Company Responses to Consolidated Agencies' Comments on the A-12 Work Plan

8/4/2020

PROJECT
GAY MINE
A-12 SURFACE WATER DIVERSION

Figure 1 – A-12 Pit Surface Water Diversion Alternatives – showing proximity of previously mined areas, overburden areas, and Mill Shale Piles to the Project.

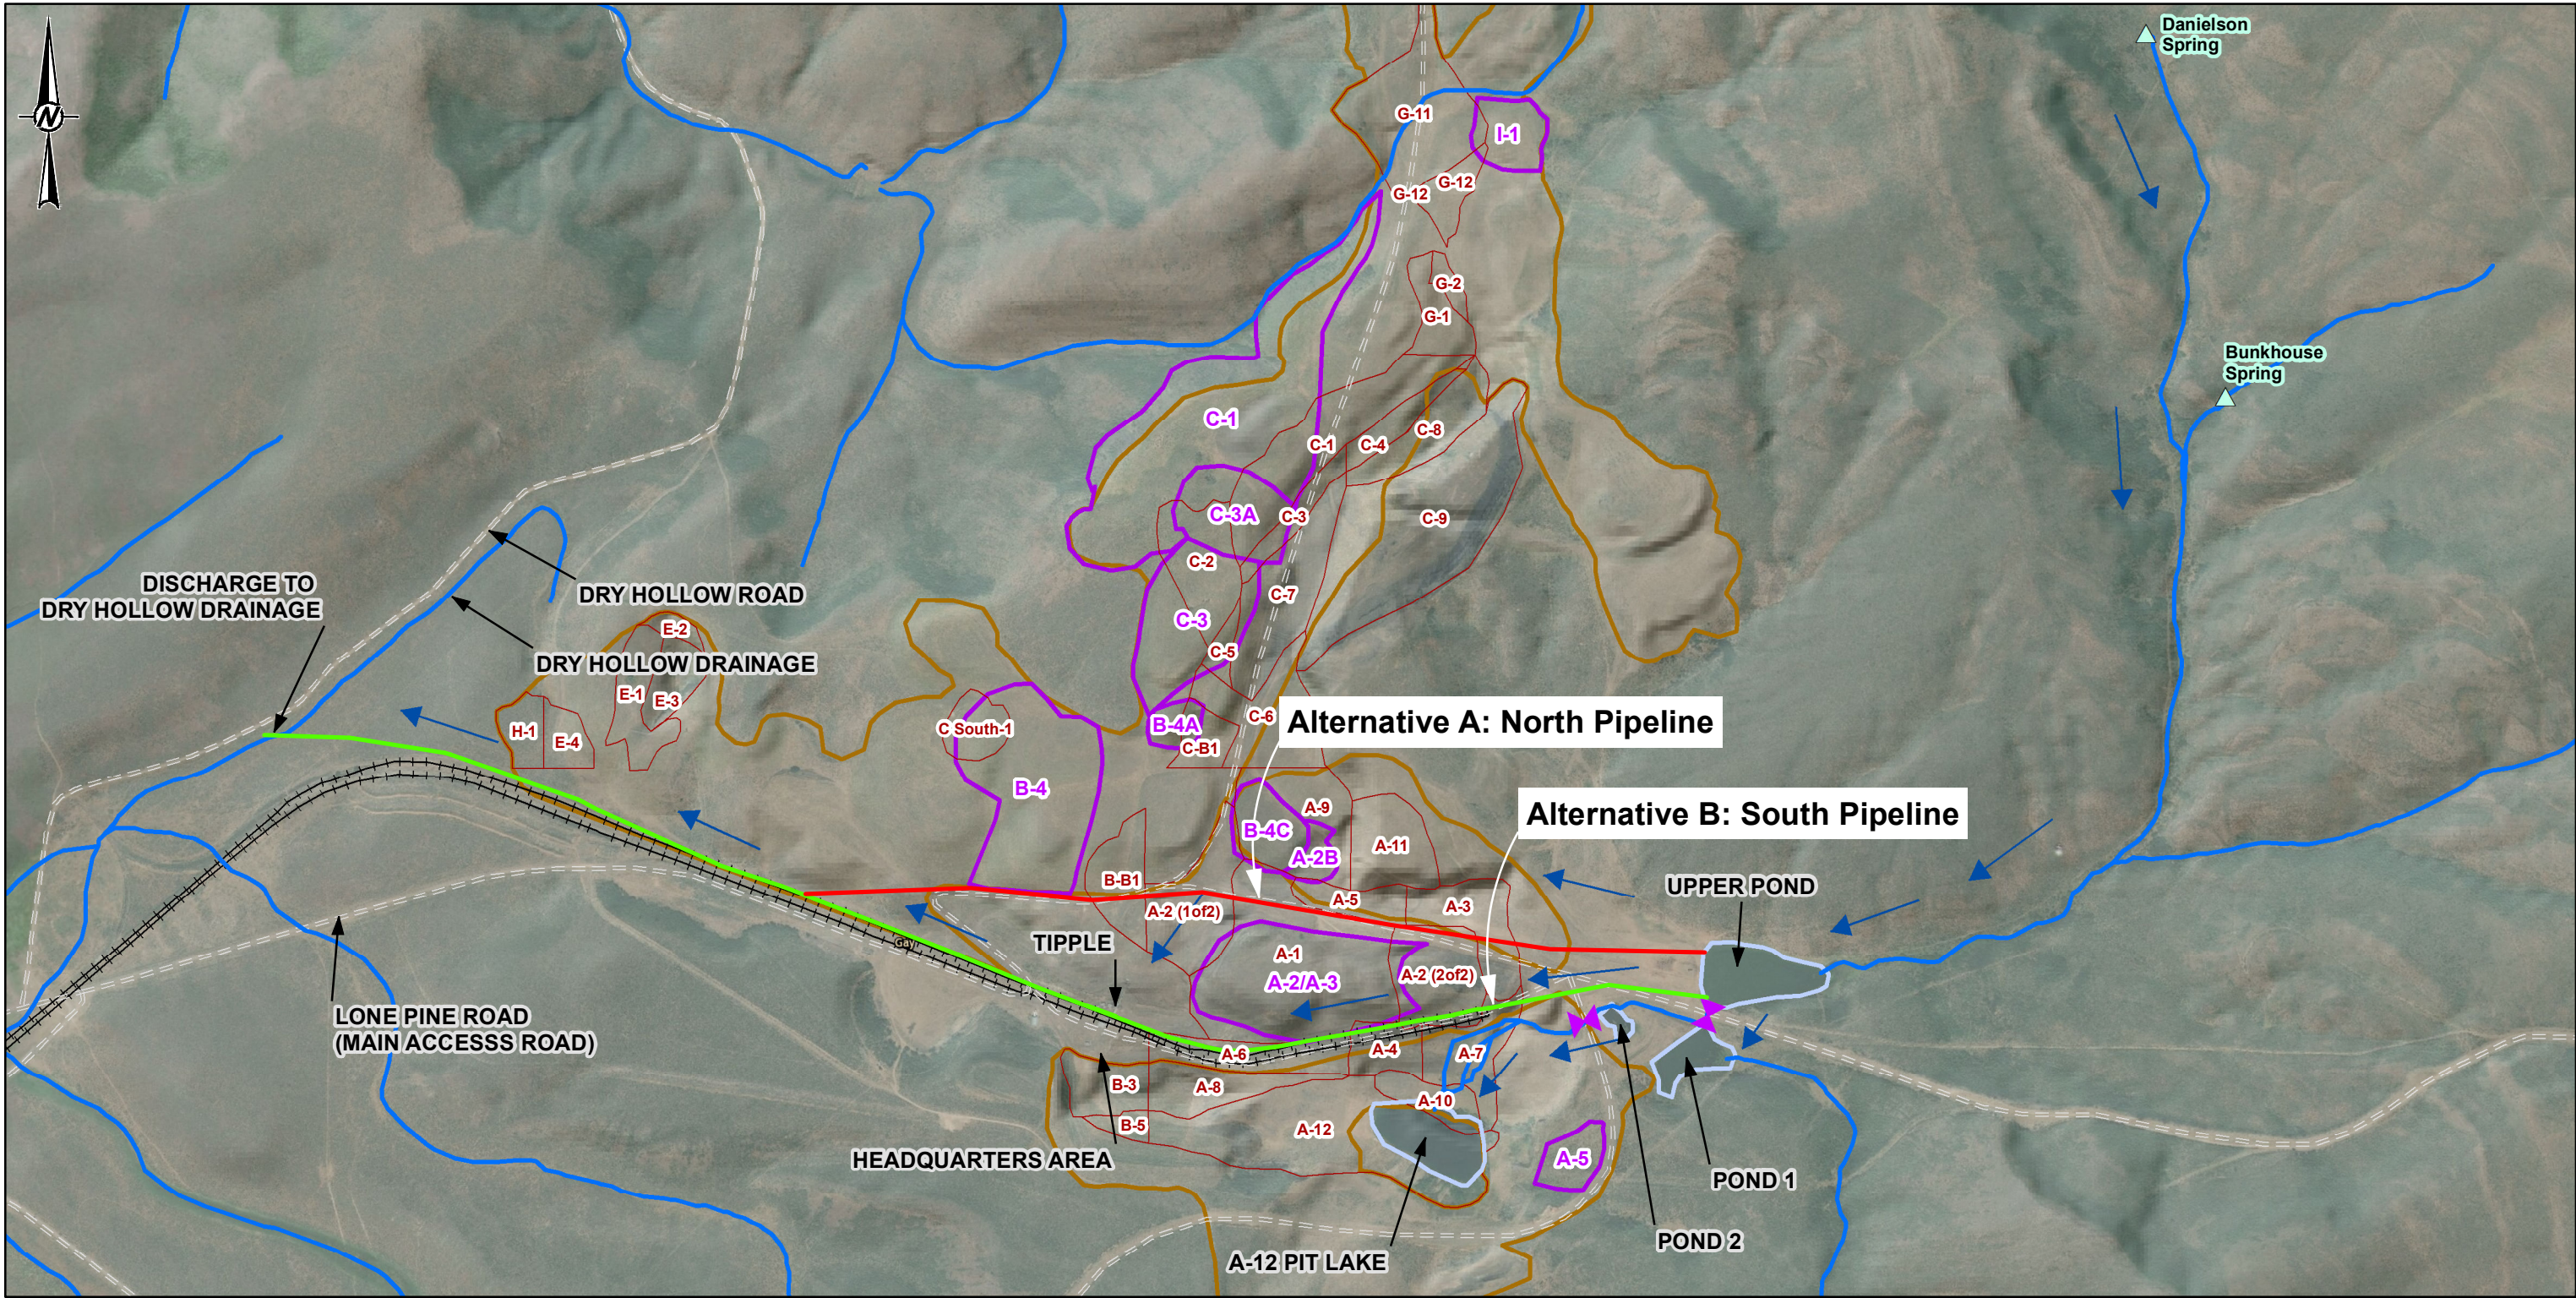
3. There is a backfilled pit (E-Pit) just east of the outfall area. Have you looked at the outfall area to determine what direction the water will flow once it leaves the pipe/ditch? Efforts must be taken to ensure the water does not flow into the pit.

Response: The proximity of previously mined areas, ODAs and Mill Shale piles is shown on the attached Figure 1. As shown on attached Figure 1, Pit E should be north of and at a higher elevation than the diversion pipe outfall location; however, The Companies will revise the Work Plan to add Section 7.0- Supplemental Survey, which will include a proposed field survey program to evaluate the actual conditions affecting the discharge location at the Dry Hollow Drainage. This supplemental surveying will include field reconnaissance of the entire diversion alignment and review of the proximity to backfilled mine pits near the outfall. Results of the field survey will be incorporated into the EDR.
